PROJECT **123A90 - HOLLANDSE KUST NOORD WIND PARK**
BLPH Project

MECHANICAL COMPLETION DOSSIER (ONSHORE)

SYSTEM	87 Instrumentation Systems incl. general control room equipment
SUBSYSTEM	87-10-10 Junction Box 00-JE-12005 and Multi-core cable (PCS System)

C30002041

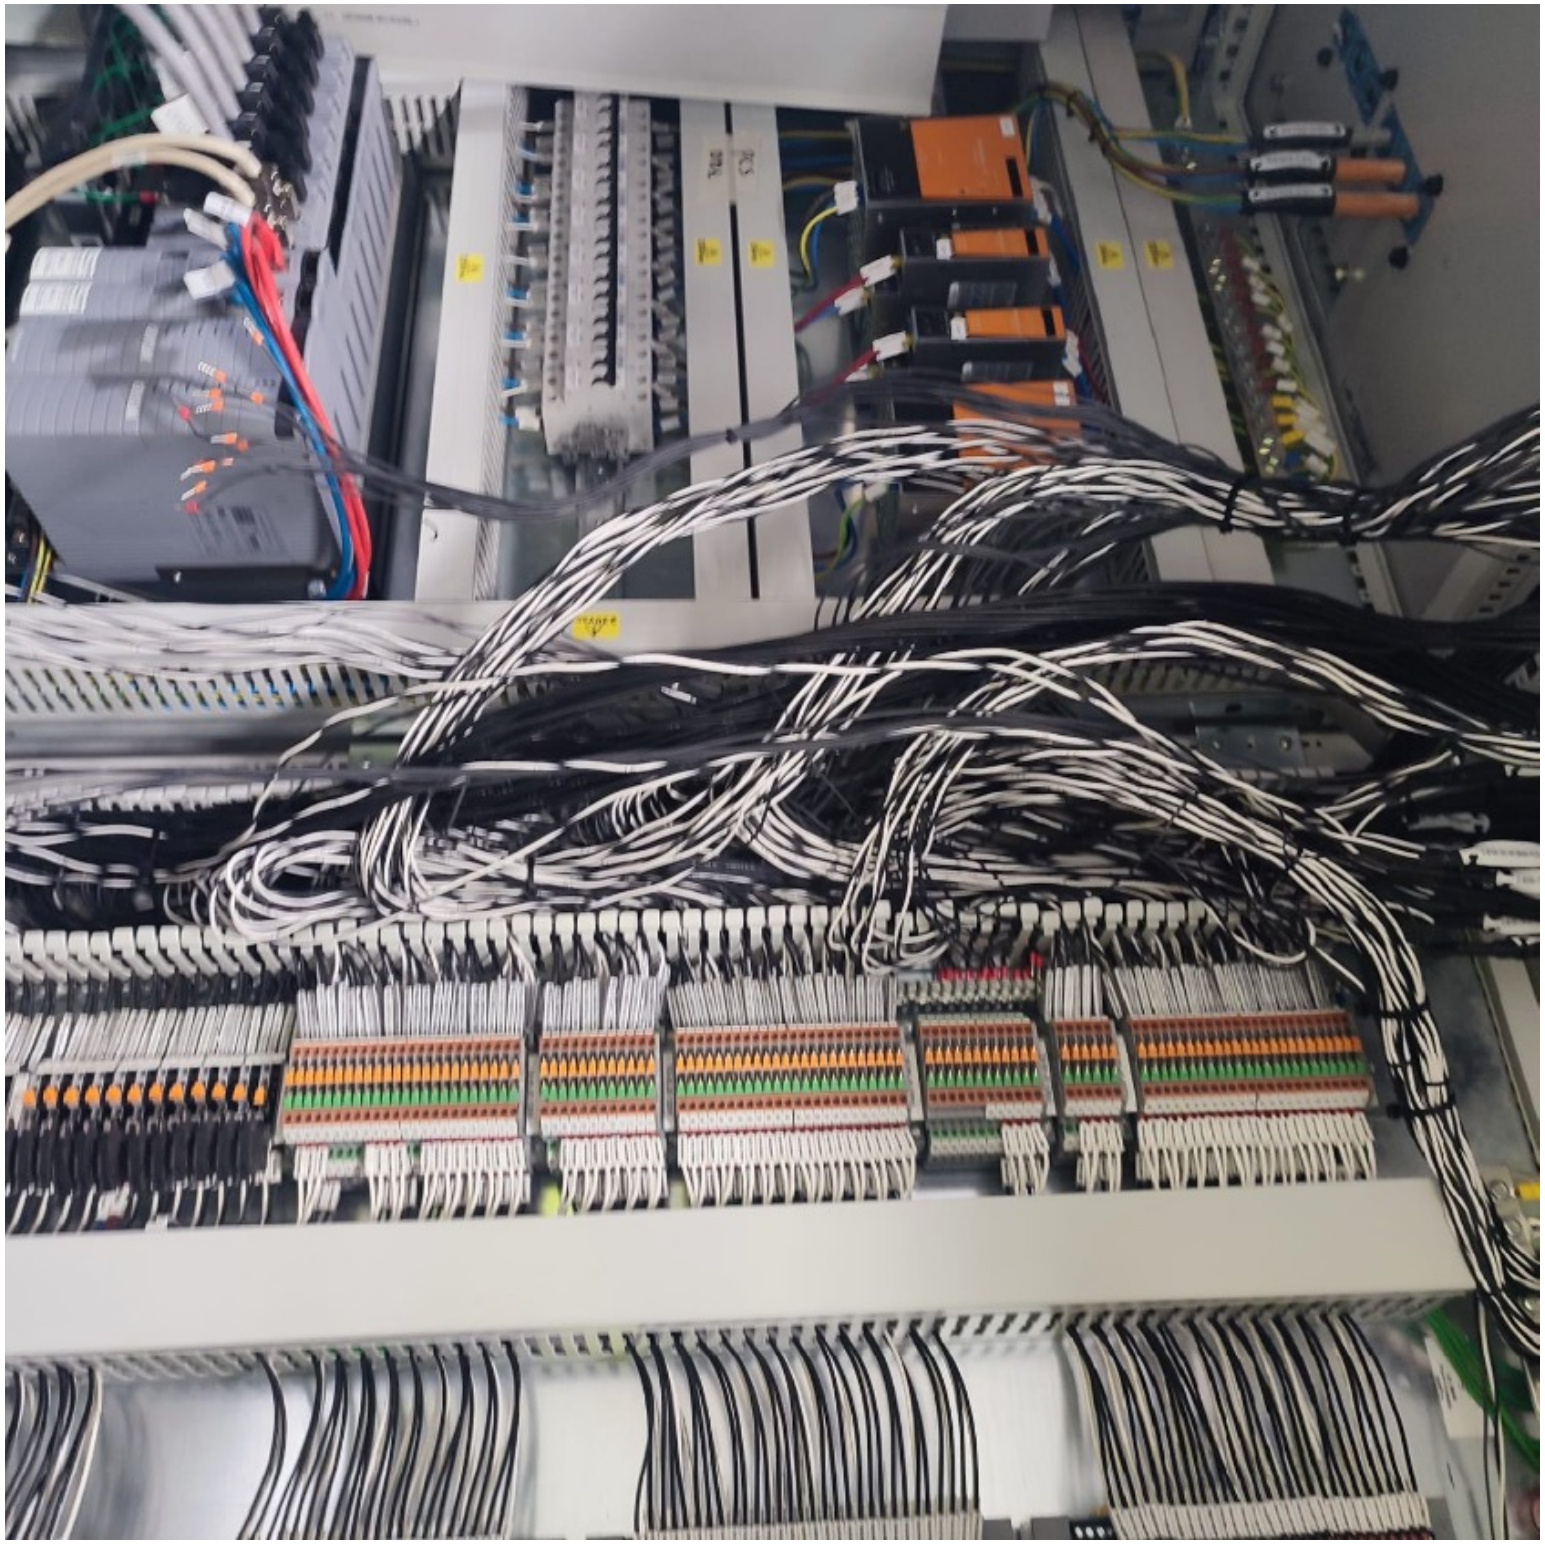
All shield as not connected on the terminal board. side the (B400-PCS-002). See attached photo.

DONE

C30002031

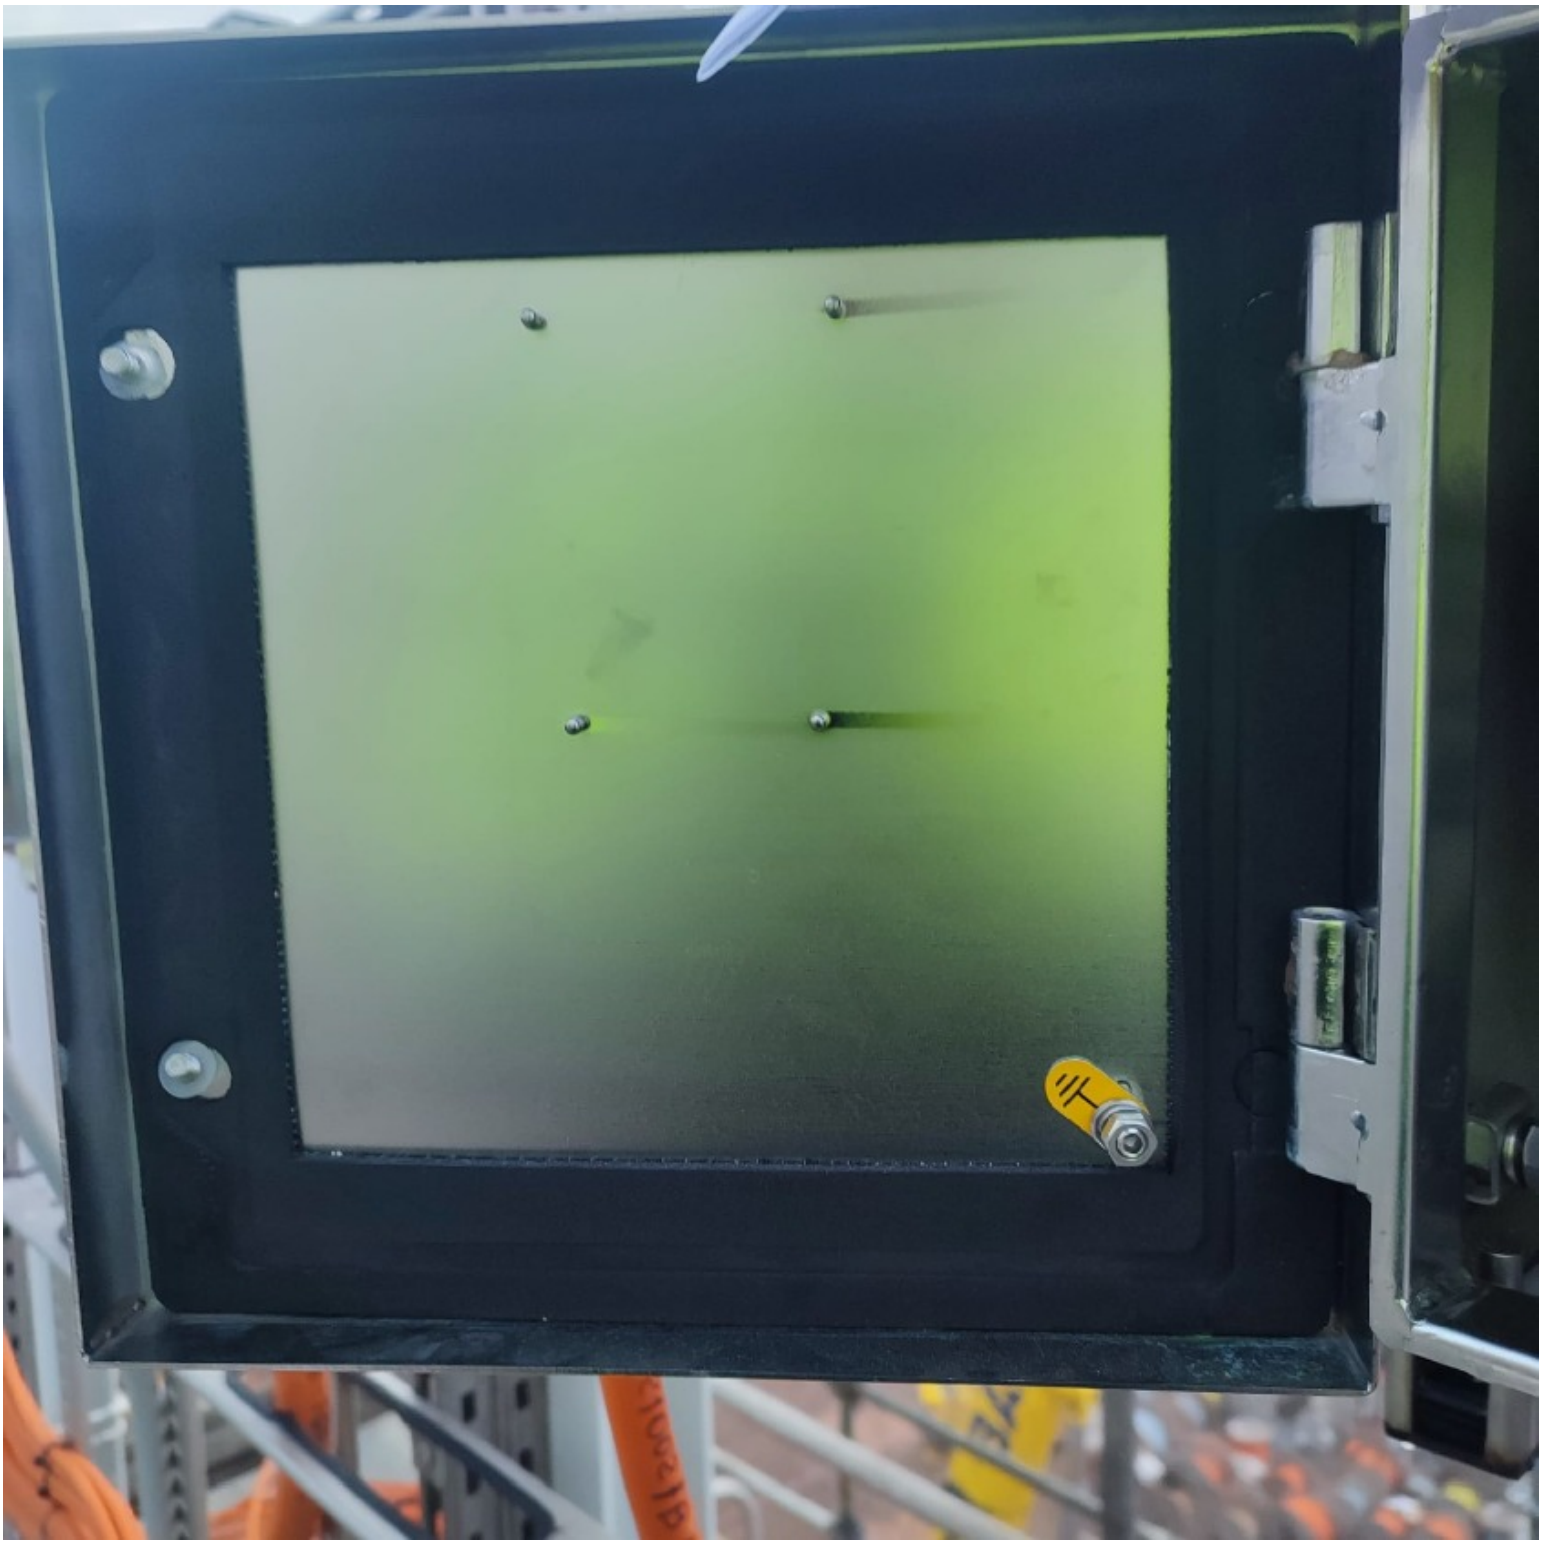
The rivets, inside the cover, must be "sealed" with suitable material. See attached photo.

Vendor declare that rivets used by Cortem to fix the tags on the cover of the
junction boxes series CTB have been tested and certificated to guarantee the degree
of protection of IP66.
